# Public Works Standard Drawings Subcommittee Meeting

Monday, April 19, 2021

# Division 4000: Water Distribution

STANDARD DRAWING NO.  
**4110**

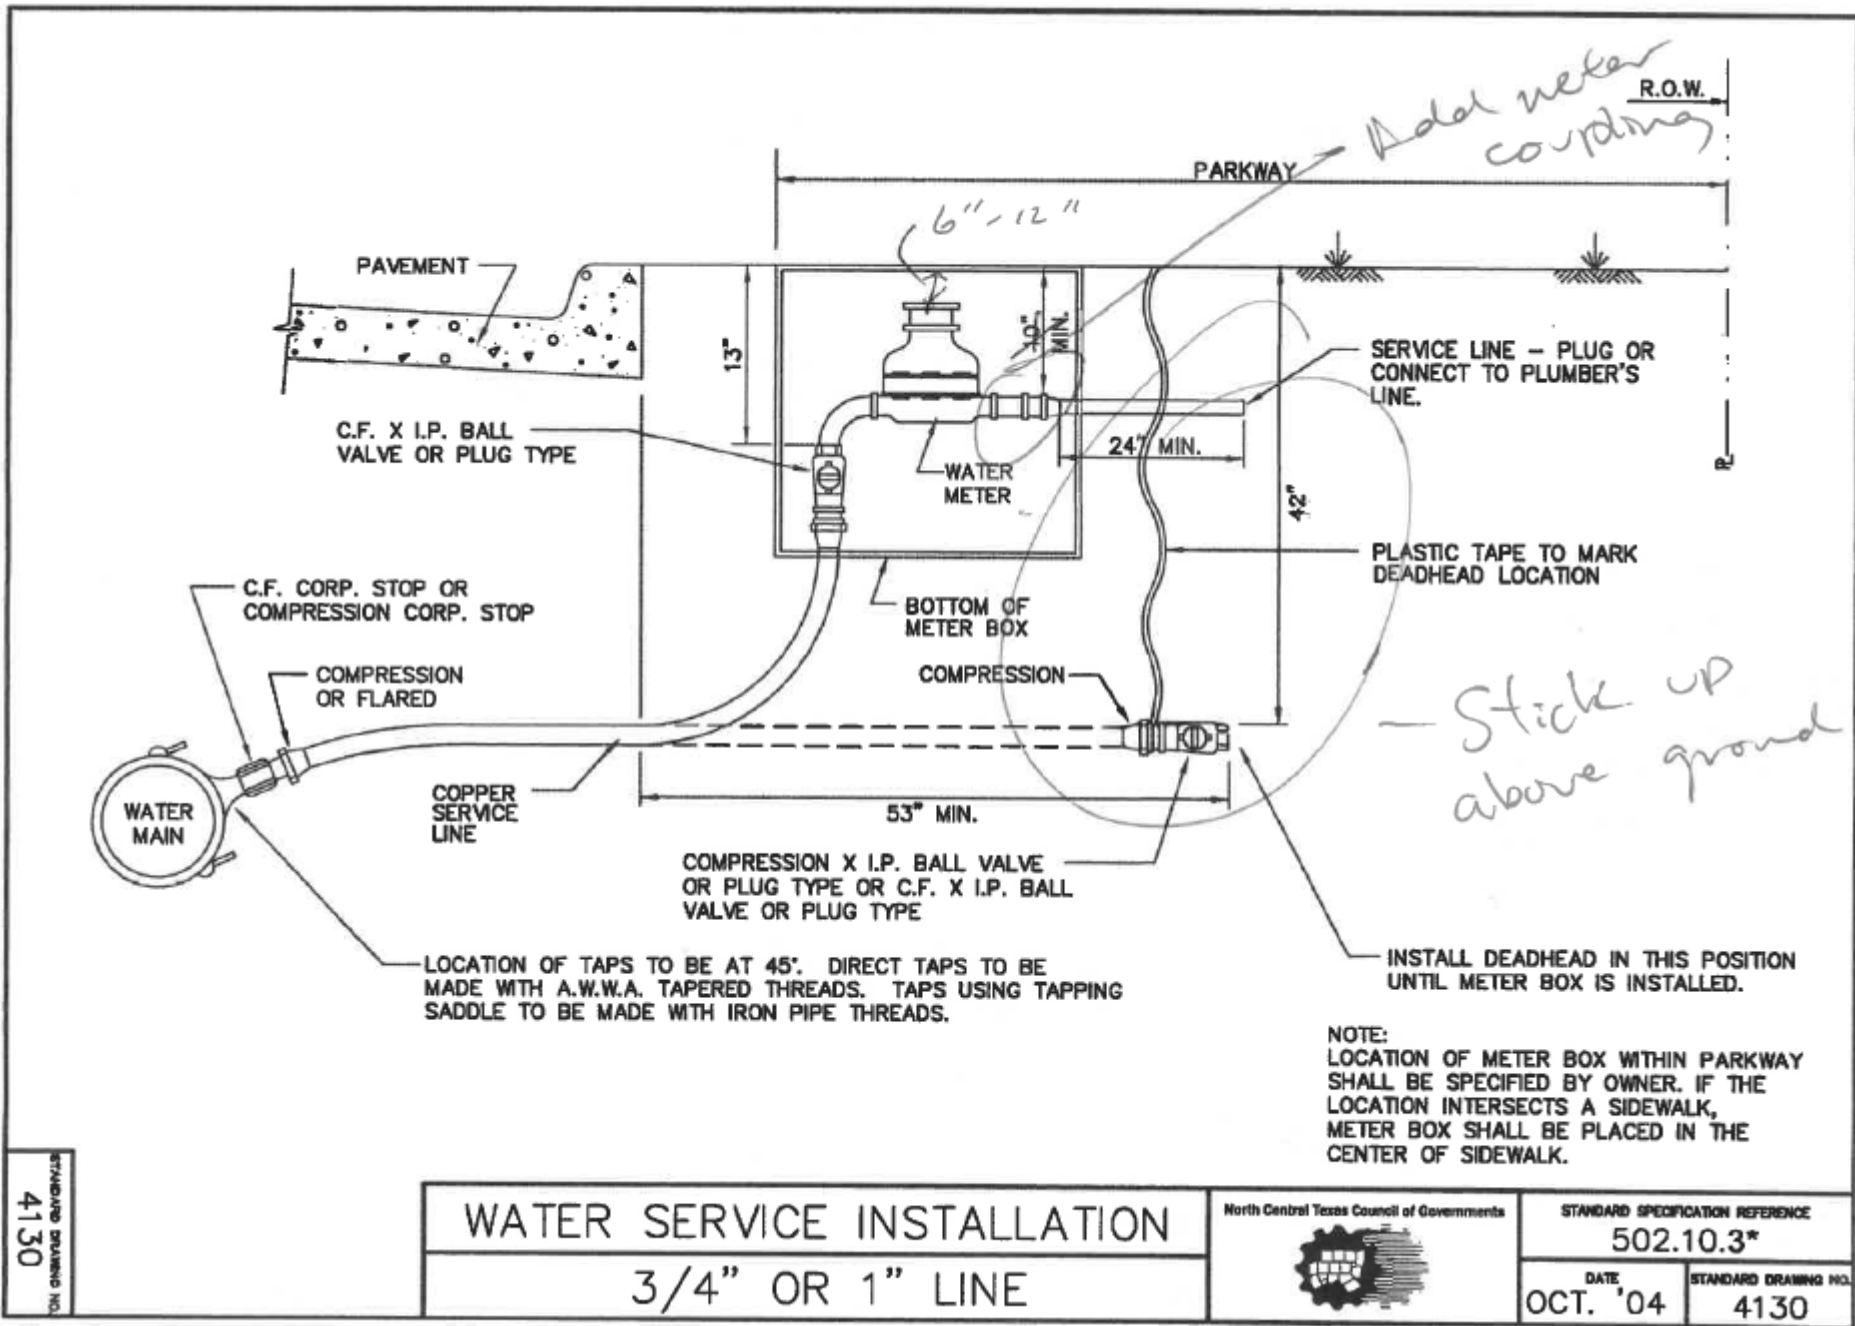
*Have a standard 450 tap.*

STANDARD DRAWING NO.  
4180

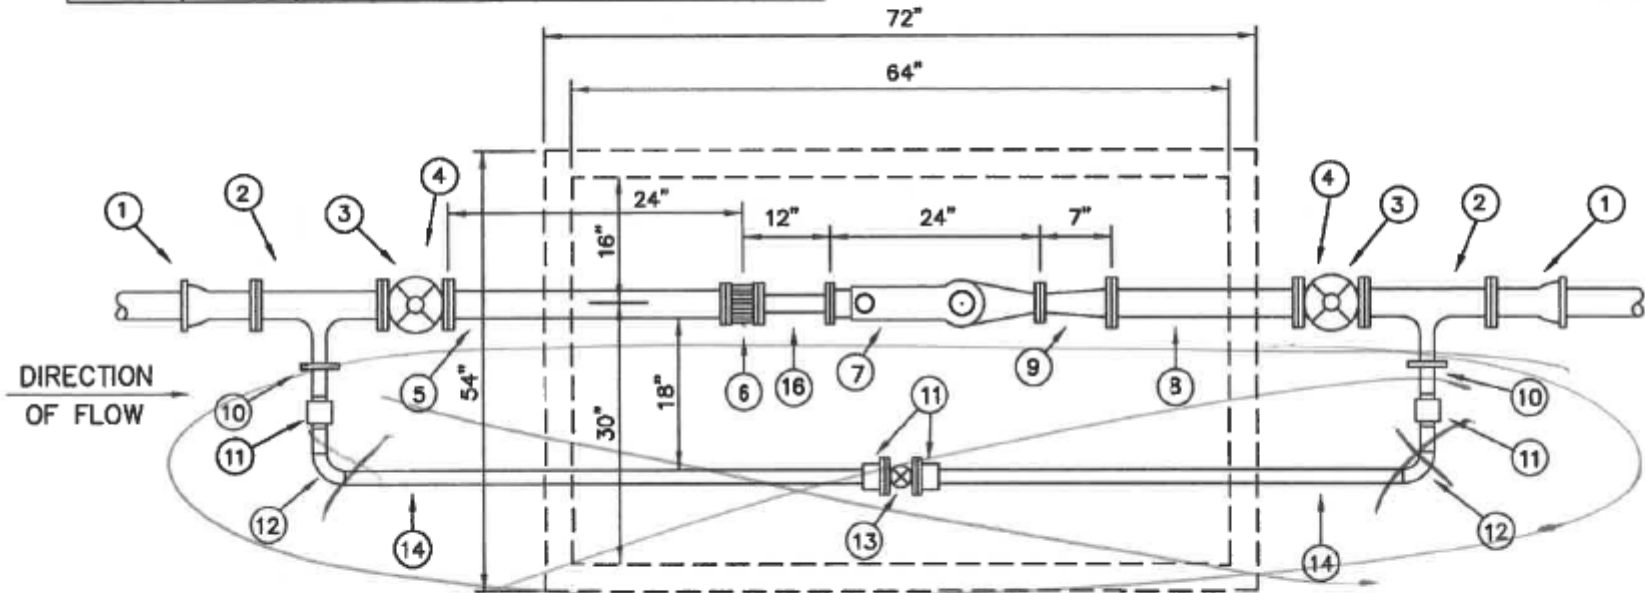
No DCDC/DCVA?

Add ball pass  
in vault
